Addendum #4 Vernon Township Public Library McCordsville Branch Buildout

Date: December 1, 2025
Project: Vernon Township Public Library – McCordsville Branch Buildout
Project #: 24025
Pages: 1 of 1 (8-1/2x11 and 24x36) pages
Bid Dates: **THURSDAY, December 4, 2025 at 2:00 pm (prevailing local time)**

Sheet MP1-1 HVAC & Plumbing Plan

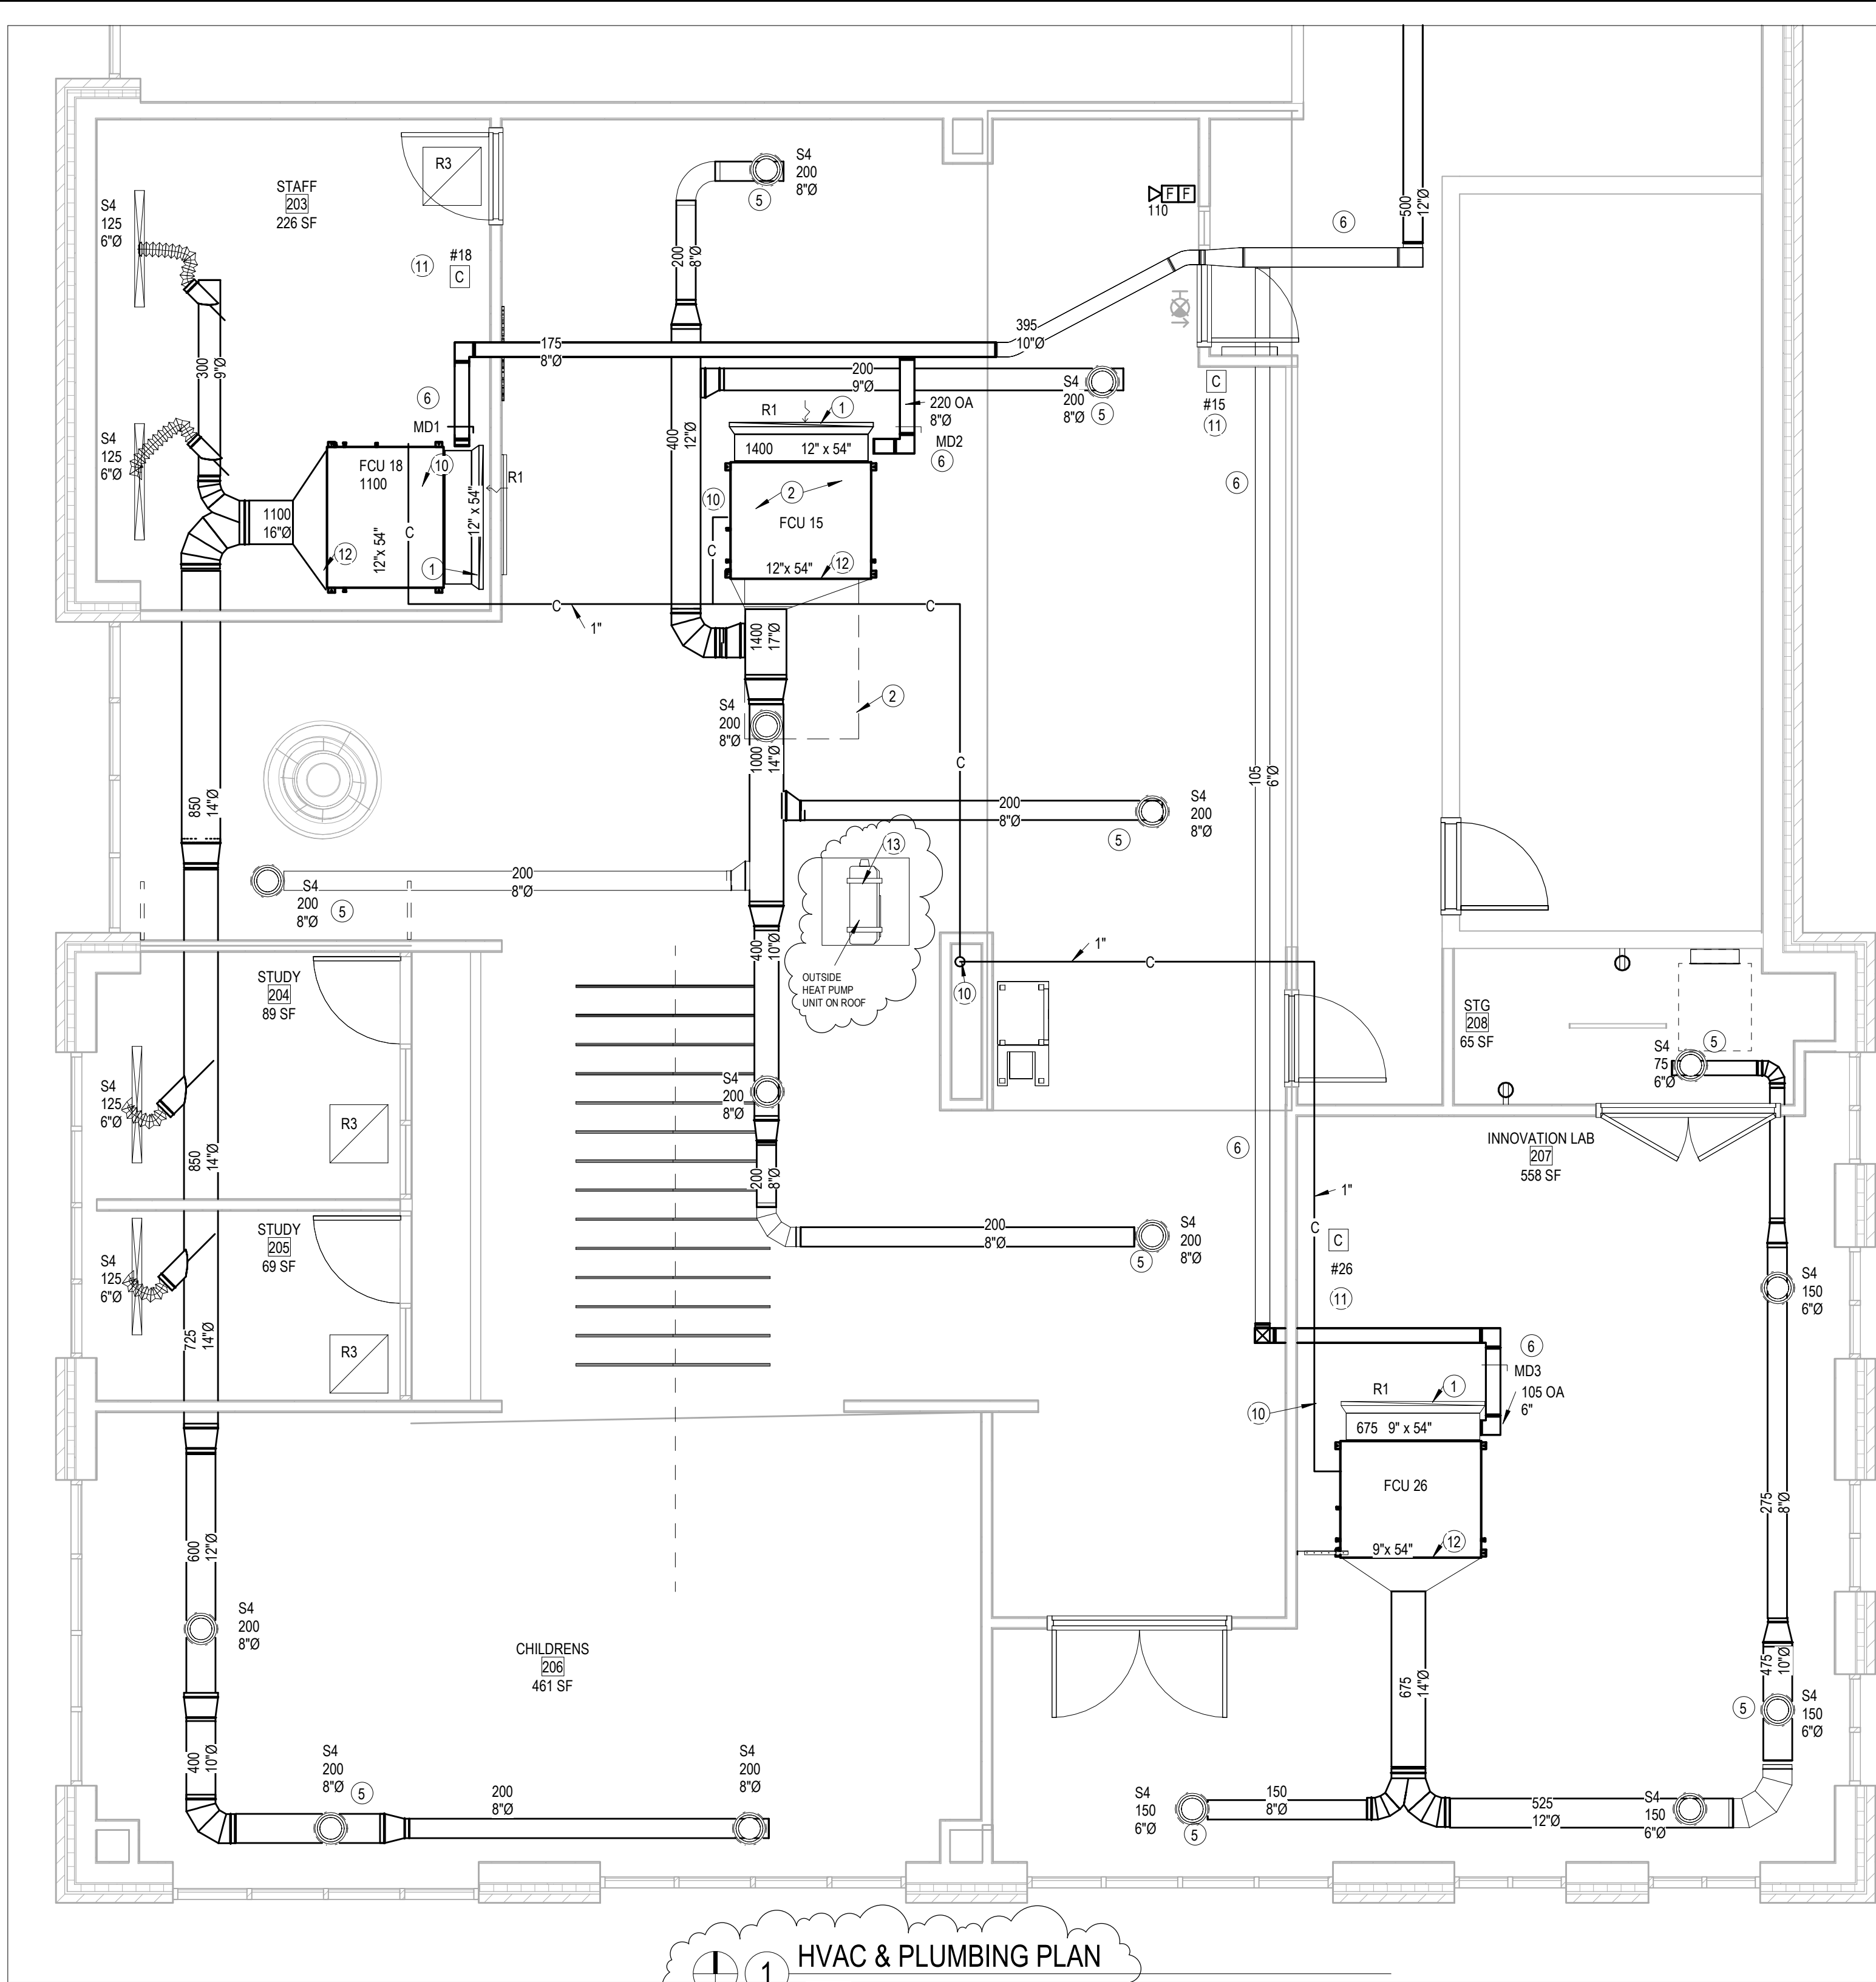
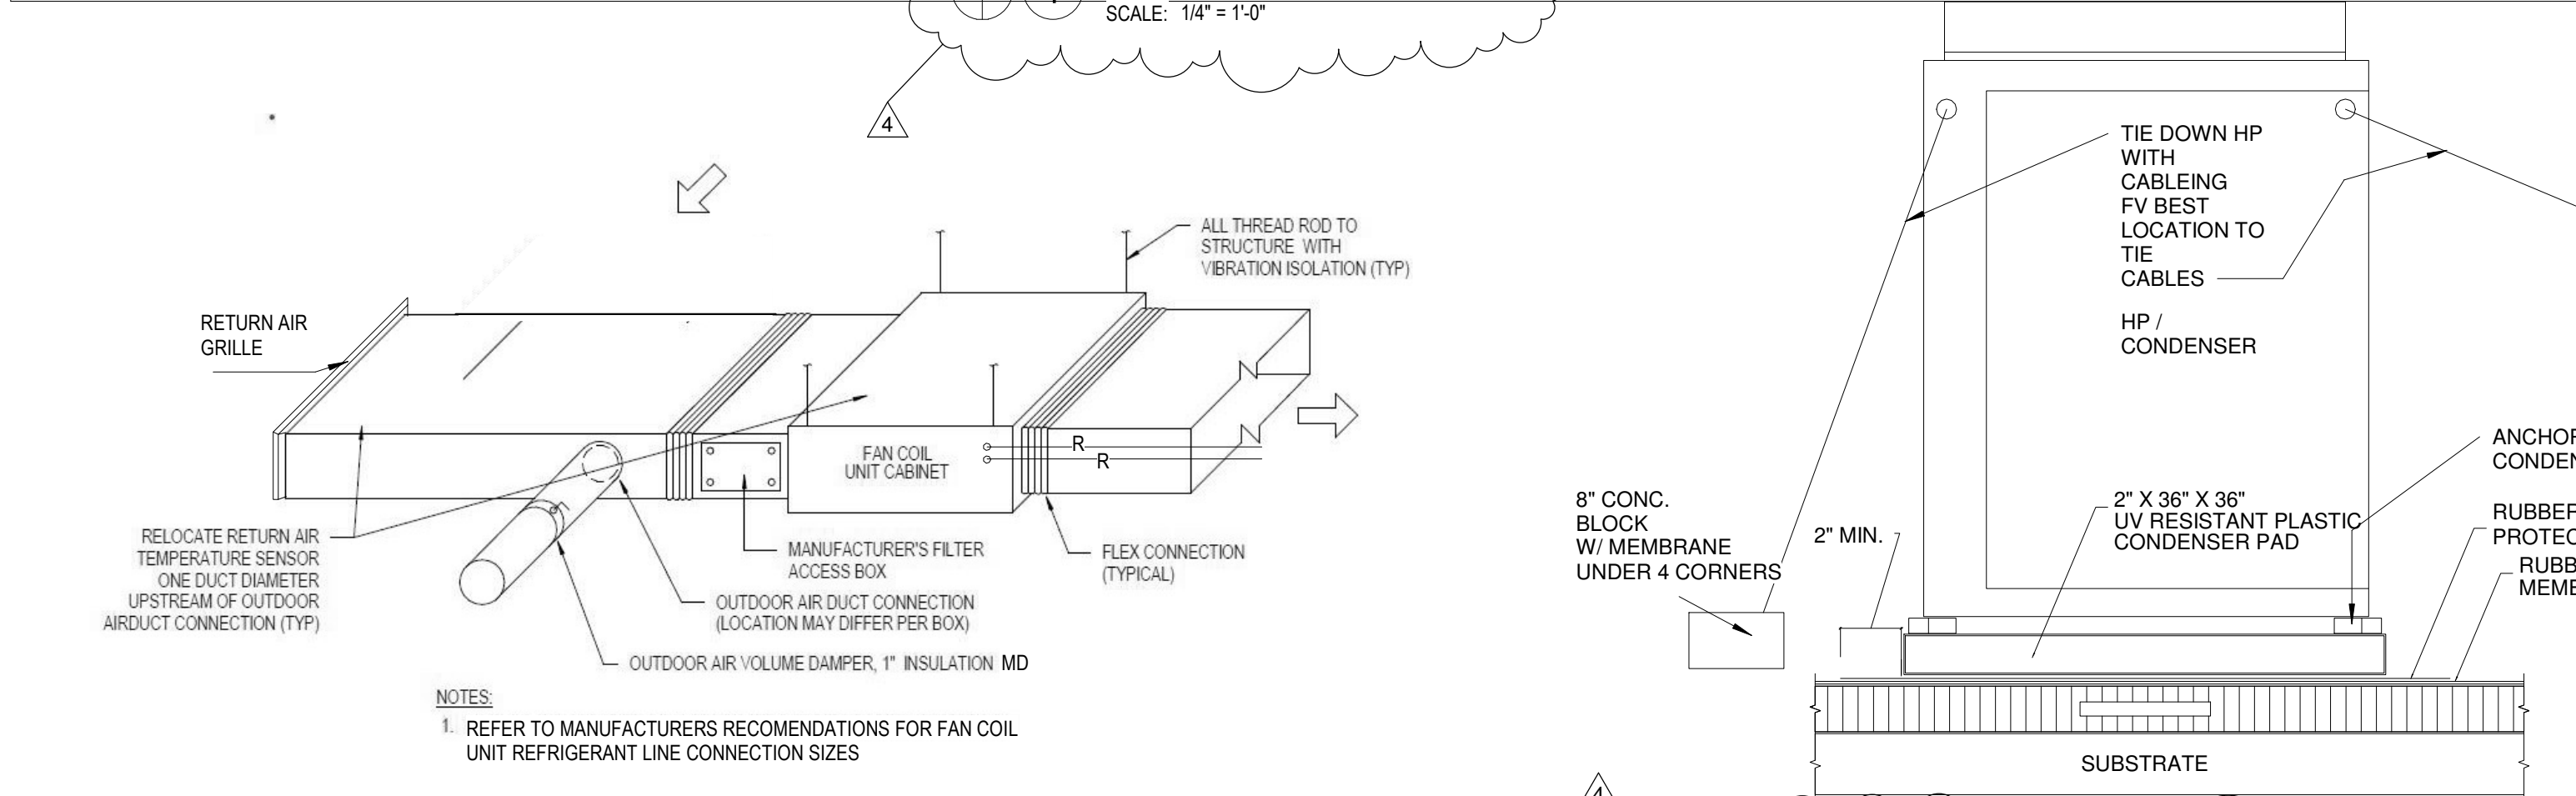
1. Revised the ductwork sizes & revised the AHU sizes. See revised sheet included.

2. Added 1 VRF 4 ton outdoor unit on the roof. Run refrigerant lines down from unit on roof. thru chase out to ducted indoor units. Coordinate with manufacturer on line length sizes and lengths. See revised sheet included.

3. OUTDOOR VRF UNIT ON ROOF WITH 36" X 36" BASE. SEE BASE DETAIL. LG # ZRUM048GSSO.

TIE DOWN UNIT W/ RUST PROOF STEEL CABLEING. USE 8" CONCRETE BLOCKS 4, TOTAL EACH CORNER. 36" X 36" BASE AND CONCRETE BLOCKS TO HAVE EPDM 60 MIL NON ADHERED 1 LAYER UNDER THE BASE AND EACH BLOCK.

COORDINATE W/ MANUFACTURER ON LINE LENGTHS & SIZES.

THE ADDED OUTDOOR UNIT ON THE ROOF & REFRIGERANT LINES TO BE AN ALTERNATE.
